**Palisades Nuclear Plant**

NUCLEAR MANAGEMENT COMPANY, LLC
PALISADES NUCLEAR PLANT, DOCKET 50-255, LICENSE DPR-20
REQUEST FOR CHANGE TO PALISADES PLANT TECHNICAL SPECIFICATION
MAXIMUM ALLOWED VALUE FOR VARIABLE HIGH POWER TRIP

**TECHNICAL SPECIFICATION CHANGE REQUEST
ALLOWED VALUE FOR VARIABLE HIGH POWER TRIP**

**LICENSE AMENDMENT REQUEST PURSUANT TO 10 CFR 50.90:
TECHNICAL SPECIFICATION MAXIMUM ALLOWED VALUE FOR
VARIABLE HIGH POWER TRIP**

FIGURE 1:
Proposed VHP Trip Calculated Setpoint, and New Technical Specification Allowable Value

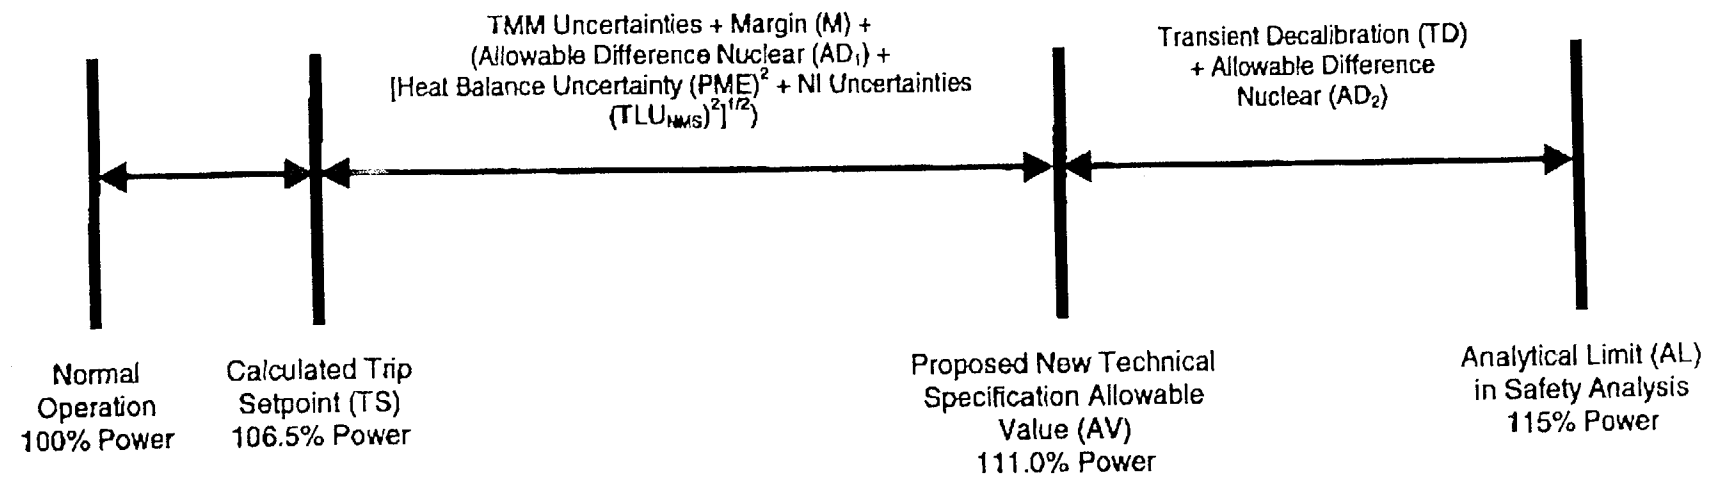
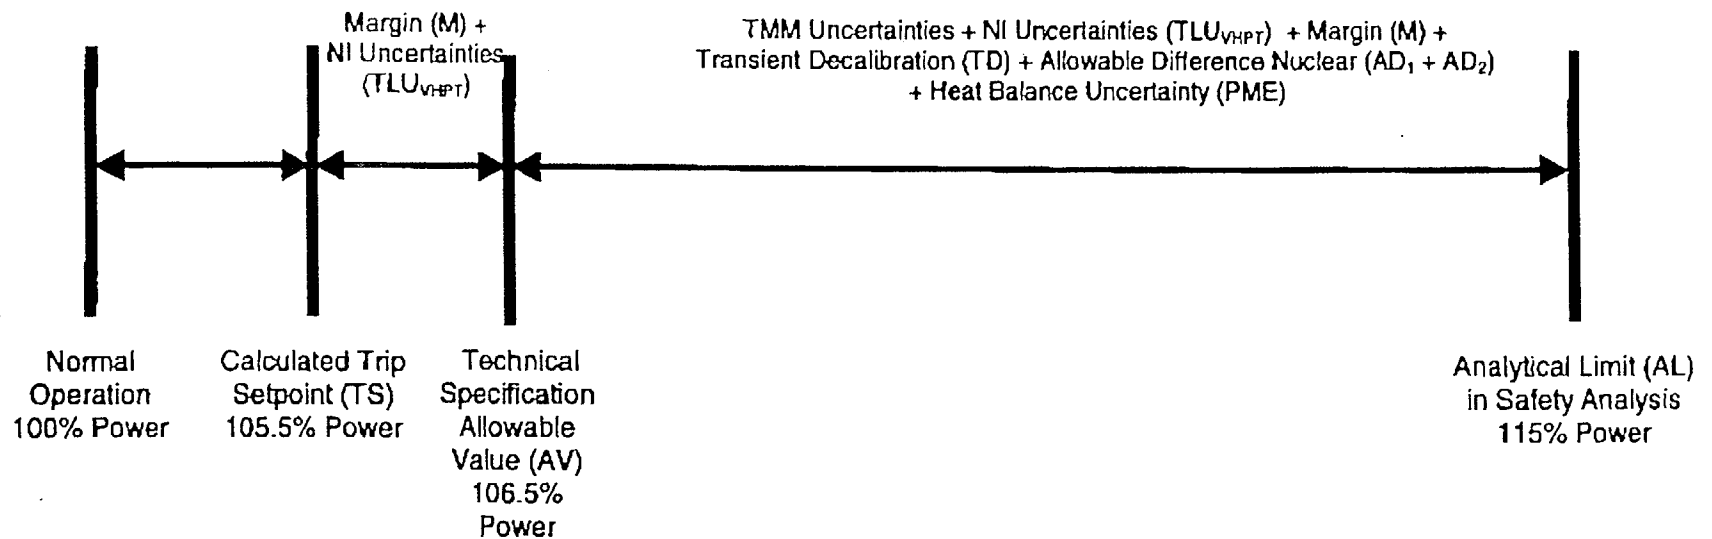
See Figure 1 for a visual representation describing how the different uncertainty terms were applied in determining the VHPT allowable value and the calculated trip setpoint. Figure 2 is included for comparison purposes. It describes the current application of uncertainty terms for the AV, TS and AL and shows how the NI Uncertainties are accounted for twice.

$$\begin{aligned}
 \text{VHP Trip Setpoint, TS} &= \text{AL} - (\text{AD}_2 + \text{TD}) - (\text{AD}_1 + [\text{PME}^2 + \text{TLU}_{\text{NMS}}^2]^{1/2}) - \text{M} \\
 &= 115\% - (1.0\% + 3.0\%) - (2.0\% + [2.0\%^2 + 0.5\%^2]^{1/2}) \\
 &\quad - 0.44\% \\
 &= 106.5\%
 \end{aligned}$$

$$\begin{aligned}
 \text{New VHP Trip Allowable Value, AV} &= \text{TS} + (\text{AD}_1 + [\text{PME}^2 + \text{TLU}_{\text{NMS}}^2]^{1/2}) + \text{M} \\
 &= 106.5\% + (2.0\% + [2.0\%^2 + 0.5\%^2]^{1/2}) \\
 &\quad + 0.44\% \\
 &= 111.0\%
 \end{aligned}$$
